RE: Coastal Commission's 30413(d) Report for the Proposed NRG Energy Center Oxnard, LLC Puente Power Project – Application for Certification #15-AFC-01

**Coastal Commission Report
to
California Energy Commission
on
Application for Certification 15-AFC-01
– NRG Puente Power Project –**

**Reviewed pursuant to
Coastal Act Section 30413(d)**

Figure 1 (PSA Fig. 4-2.2, *Vegetation Communities*). Proposed location for P3 outlined in yellow. More than 75% of the site is dominated by wetland vegetation including woolly seablite, pickleweed, and slenderleaf iceplant whose wetland status is FACW, OBL, and FAC, respectively.

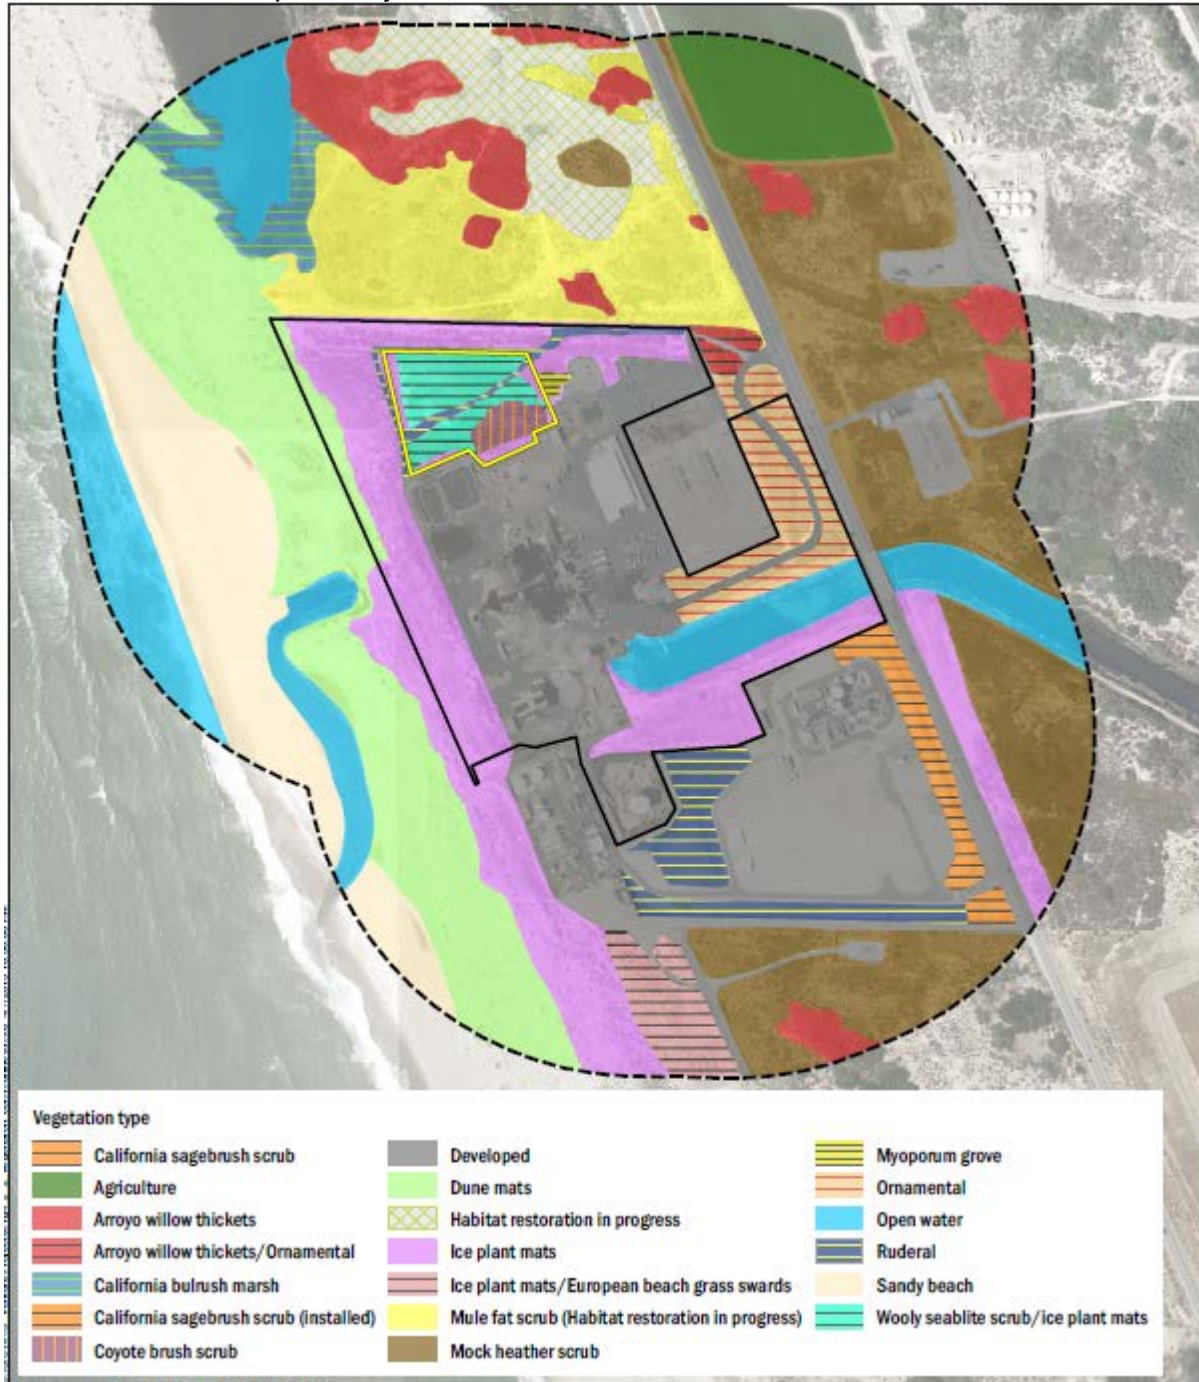
(*Mesembryanthemum nodiflorum*) (Figure 1). The National Wetland Inventory identifies the wetland status of these plants as FACW, OBL, and FAC, respectively. During the November site visit I carefully examined the vegetation in the area proposed for the power plant and confirmed that the area mapped as “woolly seablite scrub/ice plant mat” is dominated by the three species of wetland plants identified by AECOM.

Whether the soil salt content and compaction and presence of salt marsh species result from past activities or natural processes or a combination of both is not relevant because, for purposes of conformance with Coastal Act Section 30233(a), the Commission evaluates wetland indicators at a site in its present state. In this case, the area is dominated by three plants with wetland indicator status; one (pickleweed) with obligate (OBL) status meaning it is found in wetlands greater than 99% of the time, one (woolly seablite) with facultative wet (FACW) status meaning it is found in wetlands 67 to 99% of the time, and one with facultative (FAC) status meaning it is found in wetlands between 34 to 66% of the time. If the site supported just one or two FAC species, we would consider the possibility of a false positive wetland determination. However, this is not the case at the proposed power plant site.

Based on the Commission’s wetland definition, AECOM’s wetland delineation, and my site visit observations, I find that the area identified by AECOM as “woolly seablite/ice plant mat” within of the area proposed for Puente Power Plant is wetland habitat (approximately 75% of the site).

Exhibit 9b
15-AFC-01
NRG Puente Power Project
2016 Draft FEMA Flood Hazard Map
Page 1 of 1

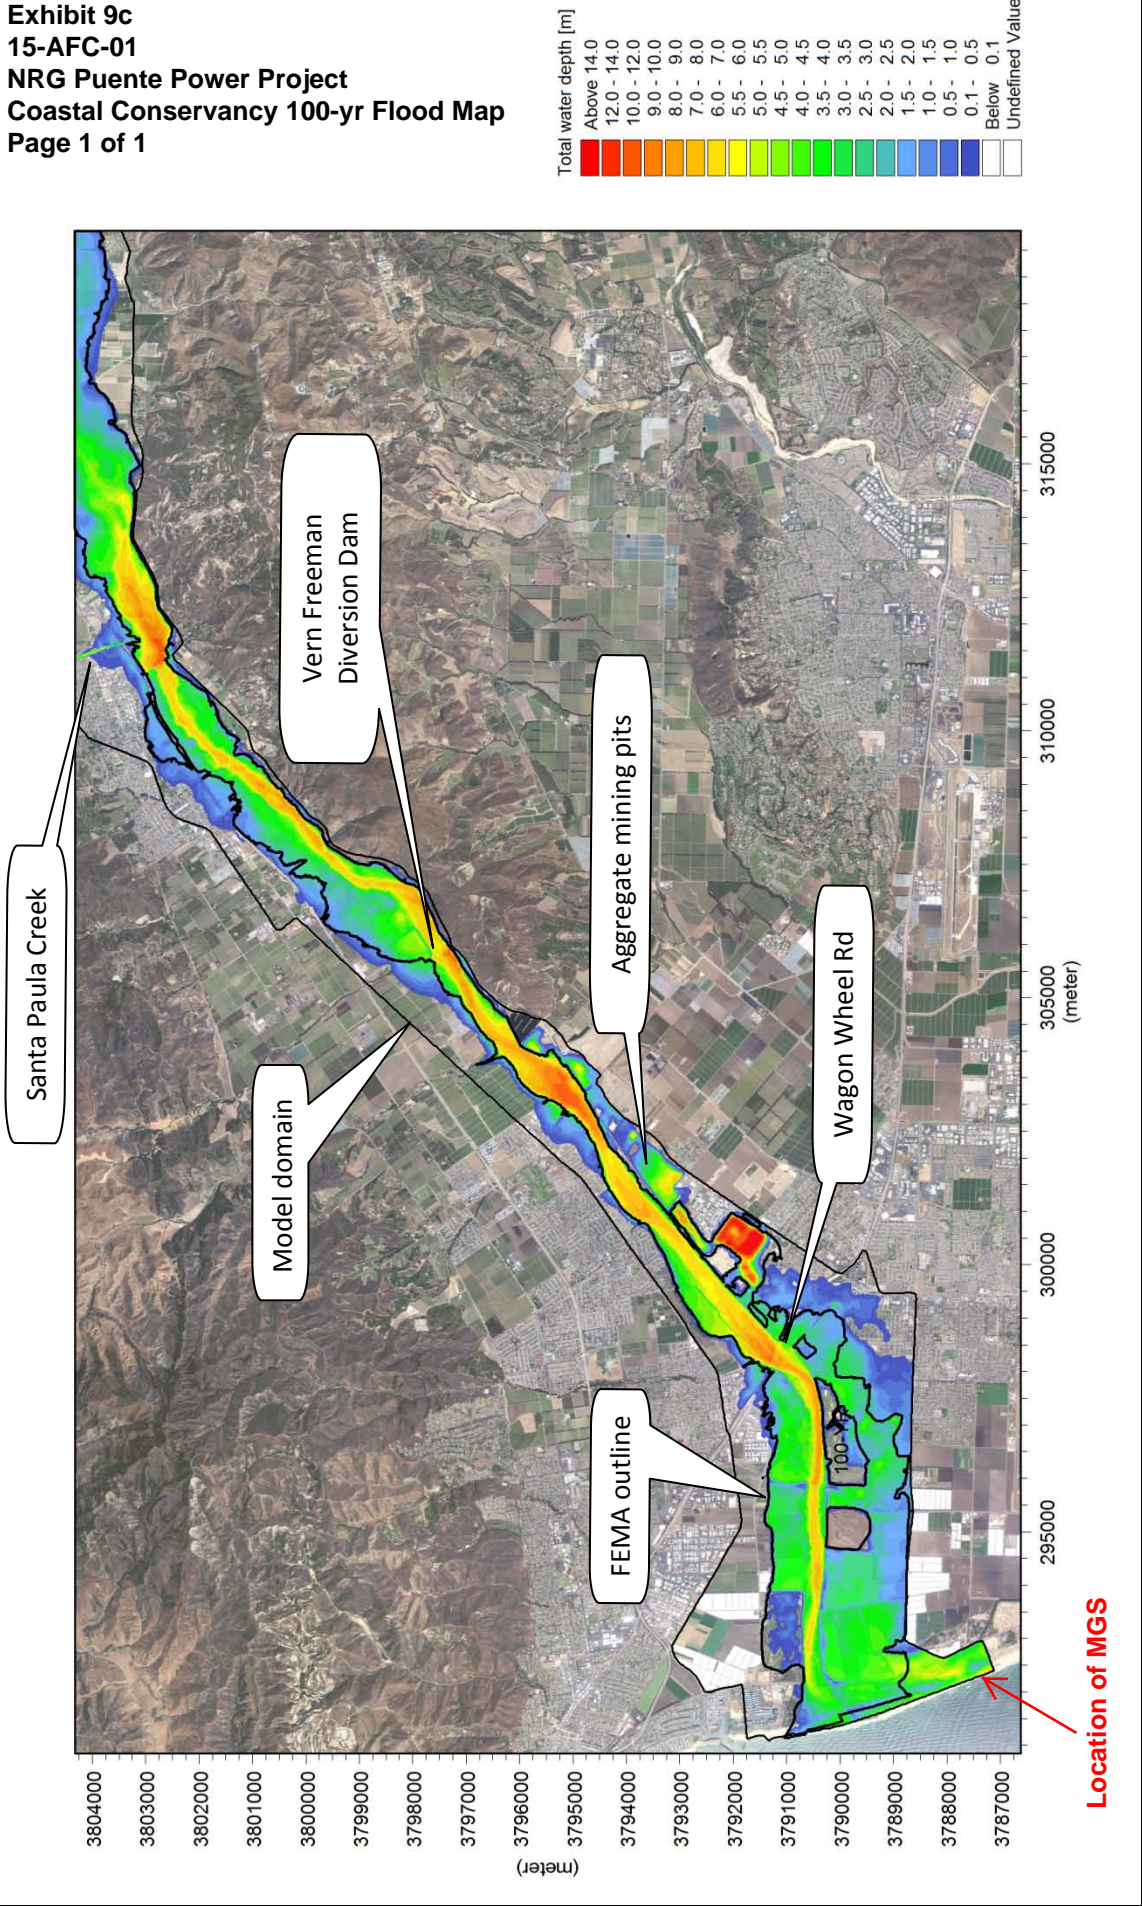
Commission staff notes that this projected maximum wave runup elevation with over 3 feet of sea level rise is lower than the *present-day* coastal base flood elevation (+20 feet NAVD88) shown on the 2016 draft FEMA flood map ([Exhibit 9b](#)). If two feet of sea level rise are added to the 2016 coastal base flood elevation, the 100-year flood zone in 2050 could reach +22 feet, which would almost certainly result in overtopping of the dunes and at least some flooding of the project site, even without accounting for erosion.¹⁷
